Access Compliance Report Public Rights-of-Way (Curb Ramps)

Main Street: N/A Cross Street: ANTONIO_PKWY Location: E

ADA ID: RPRK211122113705 Ramp Type: Type 1 - Perpendicular Diagonal Initial Pass/Fail: Fail Overall Compliance: No Severity Score: 2

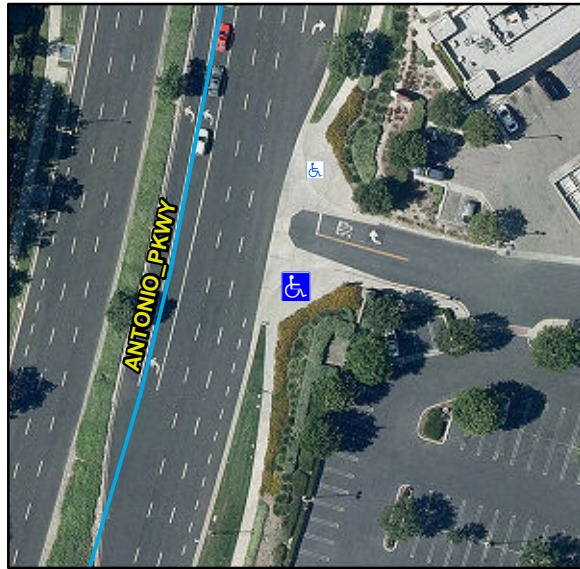
Compliance	Description	Data	Compliance	Description	Data
N/A	Ramp Length (in)	128	N/A	Flare Type LT	
Yes	Ramp Width (in)	54			N/A
Yes	Ramp Run Slope (%)	7.3	N/A	Flare Slope LT (%)	N/A
No	Ramp Cross Slope (%)	3.3	N/A	Flare Traversable LT	N/A
N/A	Landing Present	N/A	N/A	Flare Type RT	
N/A	Landing Length (in)	N/A			N/A
N/A	Landing Width (in)	N/A	N/A	Flare Slope RT (%)	N/A
N/A	Landing Run Slope (%)	N/A	N/A	Flare Traversable RT	N/A
N/A	Landing Cross Slope (%)	N/A	N/A	DWS Provided	N/A
N/A	Landing Movement Obstructed?	N/A	N/A	DWS Contrast	N/A
	Landing Movement Type	N/A	N/A	DWS Length (in)	N/A
N/A	Landing Shared	N/A	N/A	DWS Full Width	N/A
N/A	Clear Space	Yes	N/A	DWS Offset Left (in)	N/A
N/A	Clear Space To Crosswalk (in)	N/A	N/A	DWS Offset Right (in)	N/A
N/A	Marked Crosswalk 1	No	N/A	Marked Crosswalk 2	No
	Crossing 1 Direction	N		Crossing 2 Direction	W
	Marked Crosswalk 1 Width (in)	N/A		Marked Crosswalk 2 Width (in)	N/A

Remove & Replace Curb Ramp With Two New Directional Ramps or Equivalent.
